# Access Compliance Report

## Public Rights-of-Way

Intersection ID: 13540	Main Street: LEXINGTON_AV	Cross Street: S_CALDWELL_ST	Location: S
ADA ID: DF4ADCC0888A	Ramp Type: BlendTrans1	Initial Pass/Fail: Fail	Overall Compliance: No
		Severity Score: 10

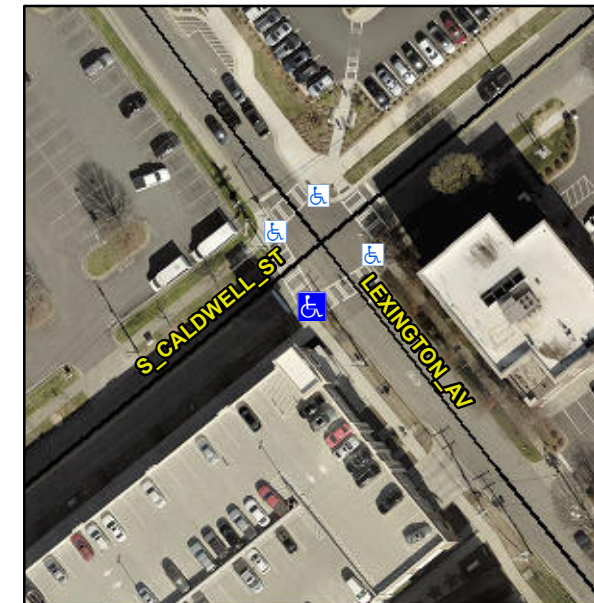
**Not Found, R304.5.1, R304.5.3**

Compliance	Description	Data	Compliance	Description	Data
N/A	Ramp Length (in)	91.0	Yes	BlendTrans Slope (%)	3.2
No	Ramp Width (in)	47.0	No	BlendTrans XSlope (%)	2.3
N/A	Flare Type LT	N/A	N/A	Flare Type RT	N/A
N/A	Flare Slope LT (%)	N/A	N/A	Flare Slope RT (%)	N/A
N/A	Flare Traversable LT?	N/A	N/A	Flare Traversable RT?	N/A
N/A	Landing Length (in)	N/A	N/A	DWS Provided?	N/A
N/A	Landing Width (in)	N/A	N/A	DWS Contrast?	N/A
N/A	Landing Slope (%)	N/A	N/A	DWS Length (in)	N/A
N/A	Landing X Slope (%)	N/A	N/A	DWS Full Width?	N/A
N/A	Landing Curb? (Y/N)	N/A	N/A	DWS Offset (in)	N/A
N/A	Shared Landing?	N/A			
N/A	Gutter Ponding?	N/A	N/A	Gutter Slope (%)	N/A
N/A	Gutter Lip Ht (in)	N/A	N/A	Gutter X Slope (%)	N/A
N/A	Painted X Walk1?	Yes	N/A	Painted X Walk2?	Yes
	X Walk 1 Direction	To NE		X Walk 2 Direction	To NW
	X Walk 1 Width (in)	113.0		X Walk 2 Width (in)	114.0
	X Walk 1 Slope (%)	6.6		X Walk 2 Slope (%)	6.4
	X Walk 1 X Slope (%)	4.2		X Walk 2 X Slope (%)	2.1

**Remove & Replace Curb Ramp With Two New Directional Ramps or Equivalent.**
